CERTIFICATE OF THE SECRETARY OF ENERGY AND ENVIRONMENTAL AFFAIRS  
ON THE  
ENVIRONMENTAL NOTIFICATION FORM

PROJECT NAME : Northern Avenue Bridge Replacement Project  
PROJECT MUNICIPALITY : Boston  
PROJECT WATERSHED : Boston Harbor  
EEA NUMBER : 16194  
PROJECT PROPONENT : City of Boston Public Works Department  
DATE NOTICED IN MONITOR : May 6, 2020

Below is a rendering of Phases 1-3 as filed with the ENF by the Proponent.

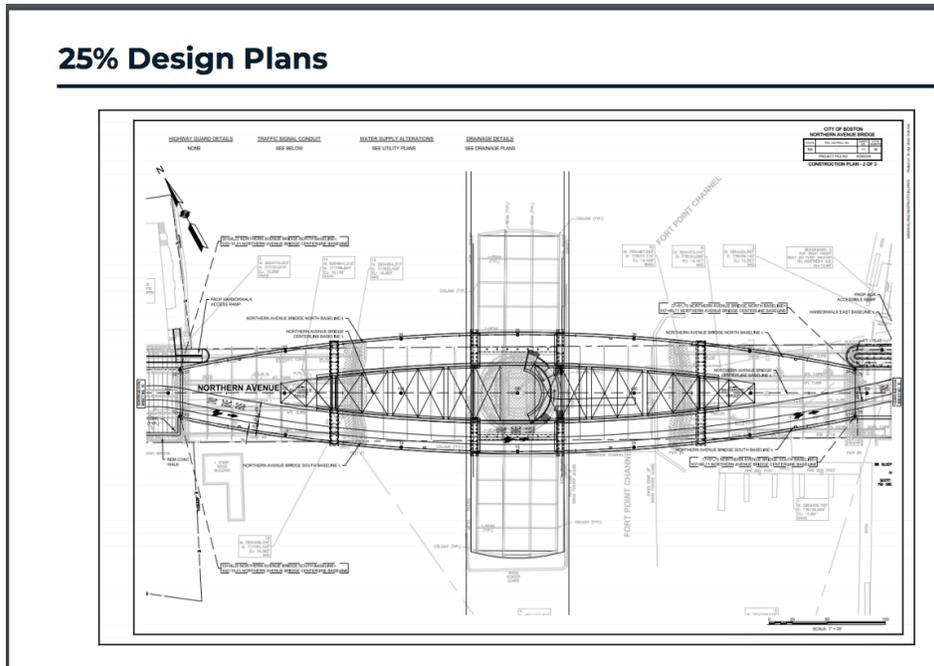
The Proponent stated at a MEPA site meeting on May 20, 2020 that the ENF is filed to advance permits for all phases, specifically Phases 1-3, not just Phase 1.

At minimum, footings and 3-D profile of the lower decks extending into the Harbor and Channel will have significantly greater impact on the watershed than the current cantilevered design.

Source: October 25, 2018 Task Force presentation

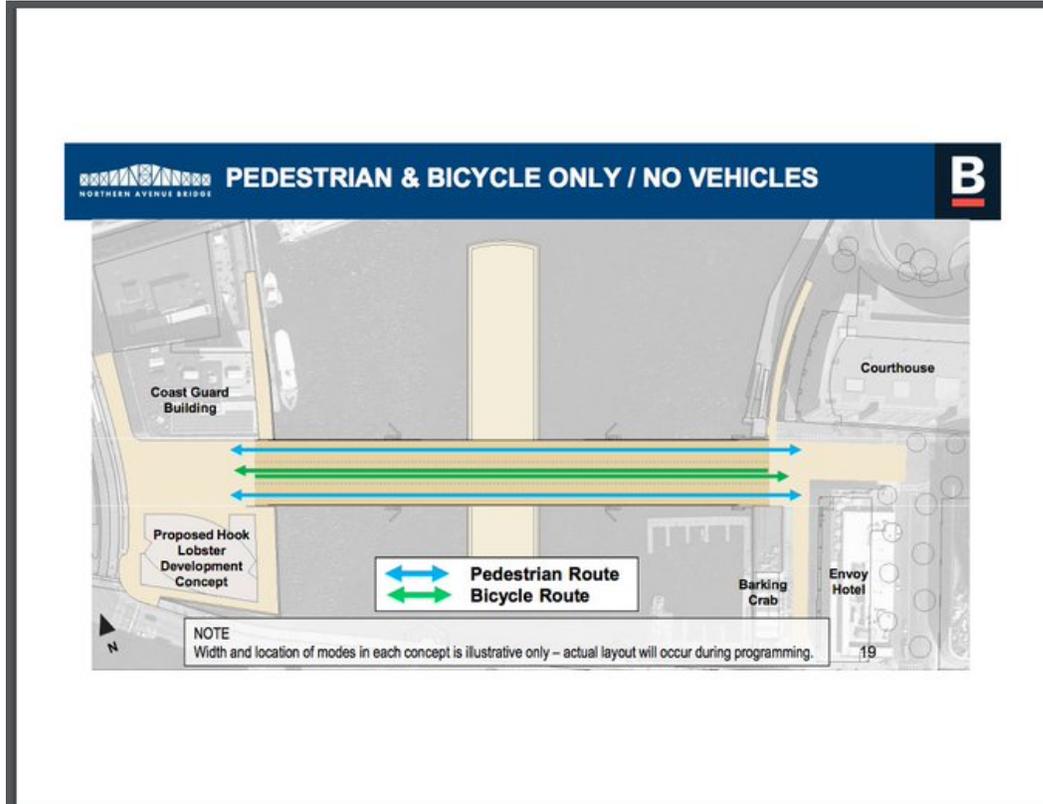
For a year of Task Force meetings, from May 2018 to May 2019, the bridge design concepts moved forward as if desired modes were not a factor in the design or scale of the bridge.

Note the pedestrian alternative presented in October 2018 is the full deck width, not a narrower design:

Source: Public Presentation, May 6, 2020

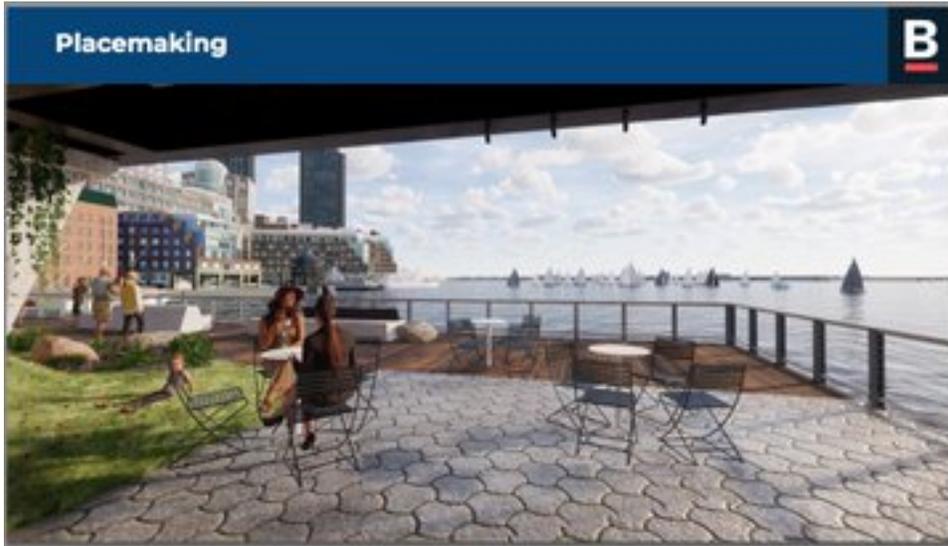
Contrary to “People First” marketing by the Proponent, pedestrians on the Promenade and lower deck will have compromised views of the watershed and will be subjected to emissions and noise from vehicles idling on lane(s) above.

The Proponent asserts that pedestrians will enjoy recreating below lane(s) of vehicular traffic. No impact study has been performed to support these assertions.
